From: [Rob Gordon](#)
To: [Tripp.Engineering \(trippeng@ec.rr.com\)](mailto:Tripp.Engineering@ec.rr.com)
Cc: [Trent Butler](#); [Brian Chambers](#)
Subject: Eng Review - The Homeplace
Date: Thursday, May 25, 2017 10:05:32 AM
Attachments: [image004.png](#)

Engineering has reviewed the plans for the Homeplace and have the following comments:

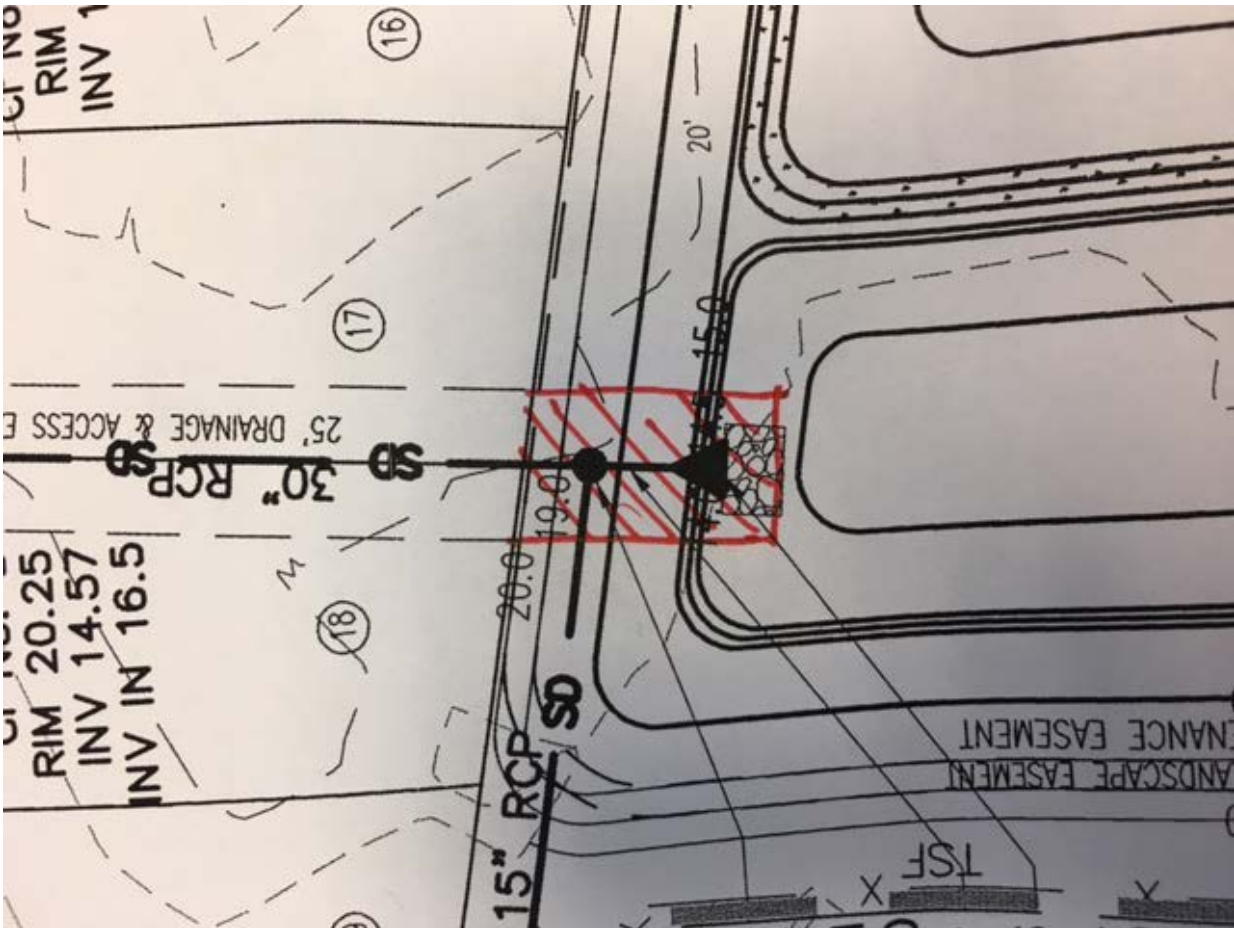
4. Regarding Beasley sidewalk, you can see where the sidewalk will be installed relative to the power lines it will be very close to the small embankment adjacent to the road. We may require the exact location to be shifted slightly in the field to maintain a shoulder from the embankment for safety. This may also affect the exact location of the pedestrian access easement. Please add a note on the plans so the contractor is aware of this.
